Attachment 1
Proposed Revisions to Chapter 15 of the Oconee UFSAR
and the Technical Specification Bases

The current small break LOCA (SBLOCA) analyses are based on the CRAFT2 Evaluation Model. A new Evaluation Model, based on the RELAP5/MOD2-B&W computer code, was approved by the staff in a safety evaluation dated February 18, 1997. This attachment provides a markup of Section 15.14 of the Oconee UFSAR to incorporate revised SBLOCA analyses based on the new Evaluation Model. The revised SBLOCA analyses credit operator actions to raise steam generator levels to the loss of subcooled margin setpoint and depressurize the steam generators.

This attachment also provides a markup of the Bases to Technical Specification 3.3 to incorporate the changes associated with the new SBLOCA analyses. Attachment 1A provides change pages for the Bases of Technical Specification 3.3.

Figure 15-45.
LOCA - Small Break Analysis Code Interfaces

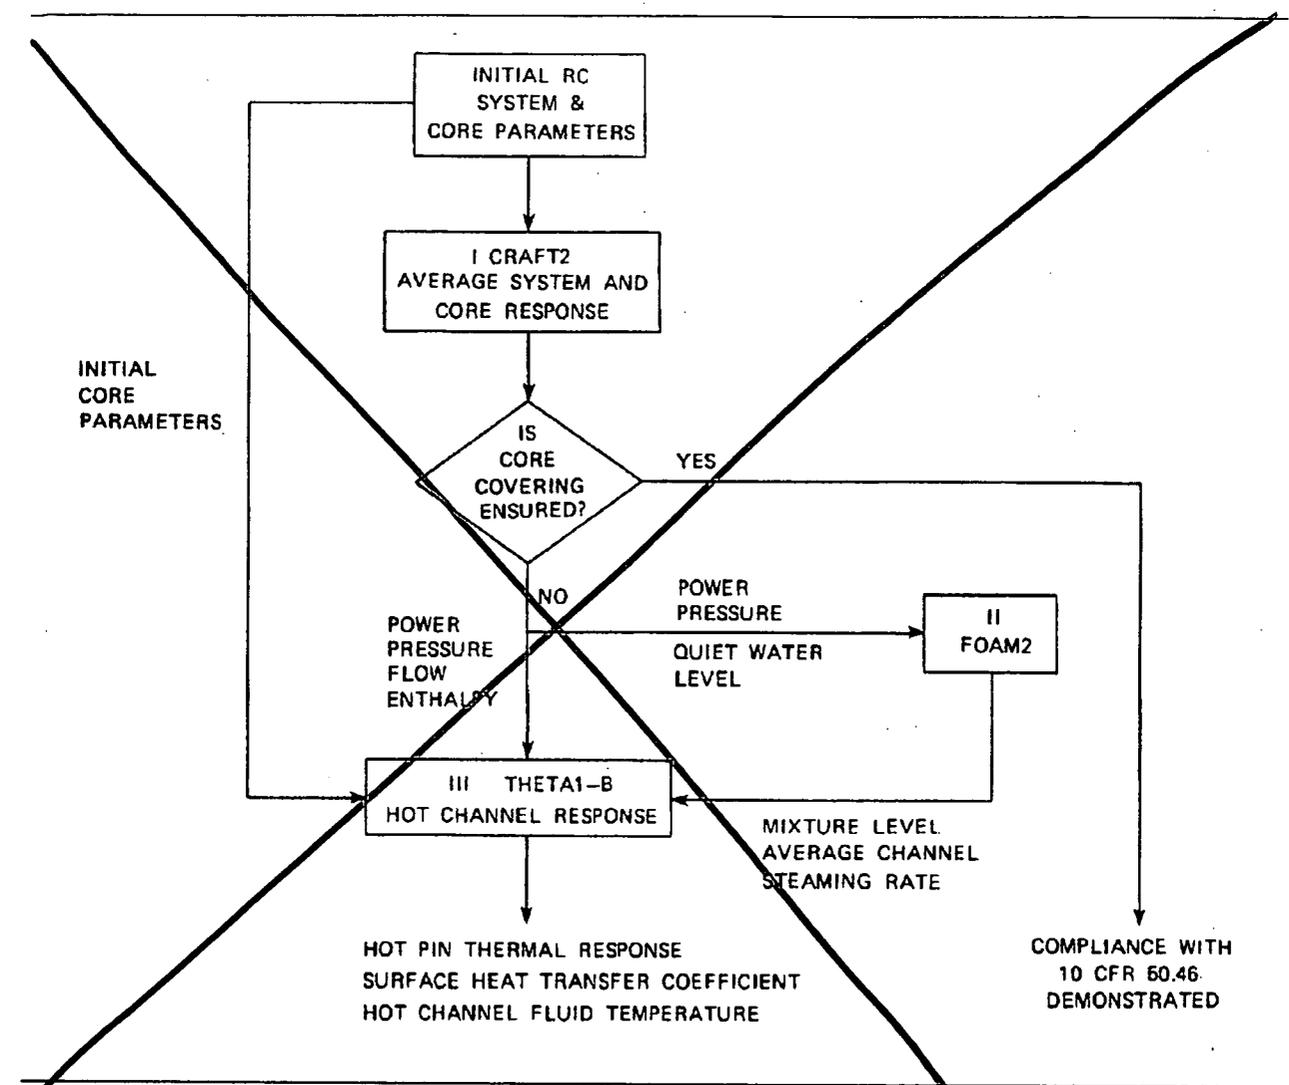
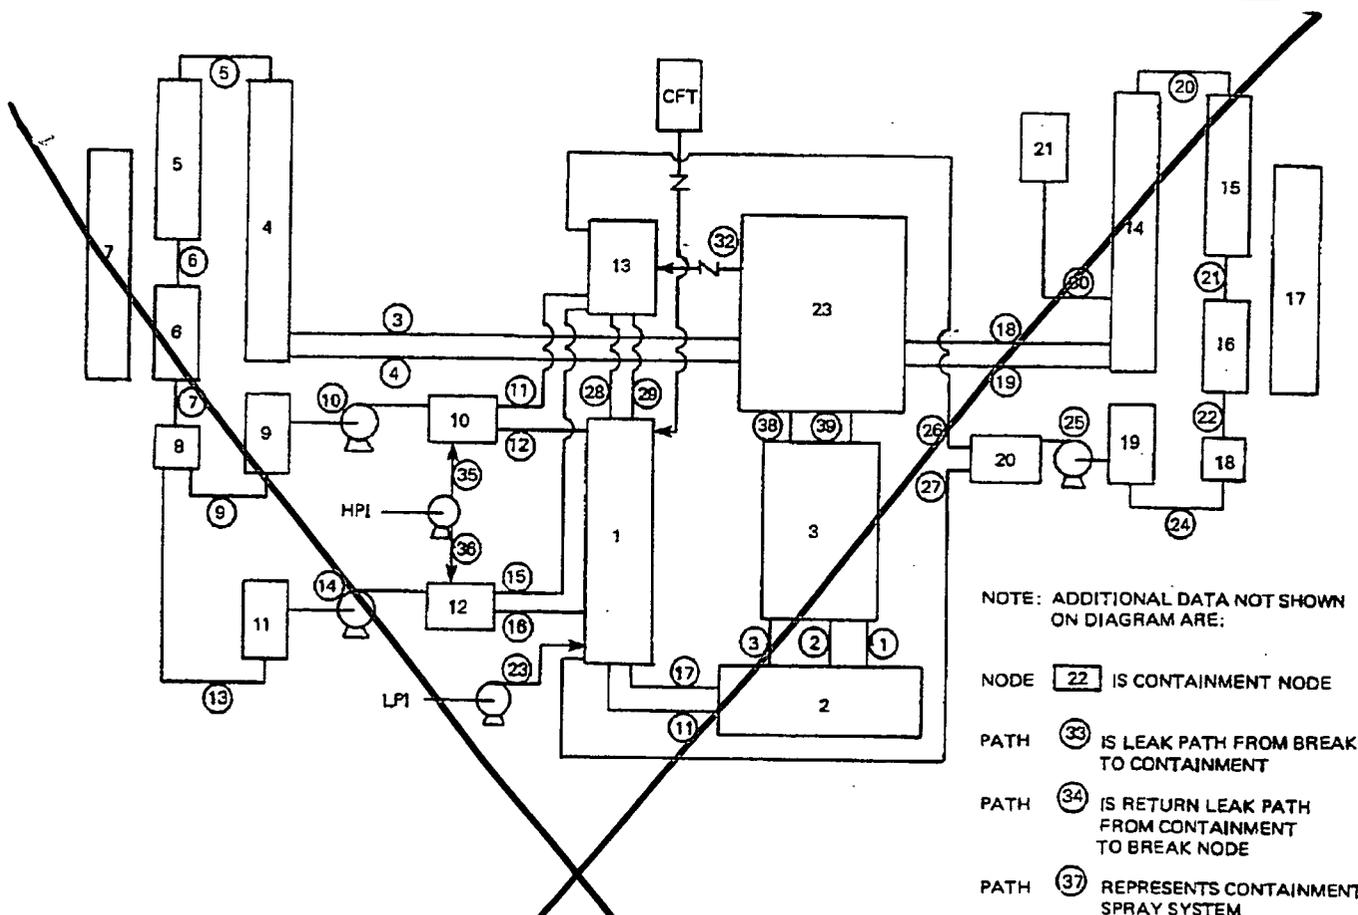
The CRAFT2 code (Reference 2), which is a modified version of the FLASH-2 code (Reference 3), solves the evolution of system hydrodynamics and core power generation during blowdown. The REFLOD3 code (Reference 4) is used to determine the length of the refill period and the flooding rates during reflood. The CONTEMPT code (Reference 5) calculates the Reactor Building pressure response. The THETA1-B code (Reference 6) is used with the output from CRAFT2, REFLOD3, and CONTEMPT to determine the fuel thermal and mechanical response and the PCT. ~~For the small break LOCA (SBLOCA) which results in core uncover, the core mixture level is calculated by the FOAM2 code (Reference 7). Clad metal-water reaction and hydrogen generation is calculated by the QUENCH code (Reference 8). The code interfaces for the LOCA are shown in Figure 15-44, and for SBLOCA in Figure 15-45.~~ ^{large break}

delete

delete
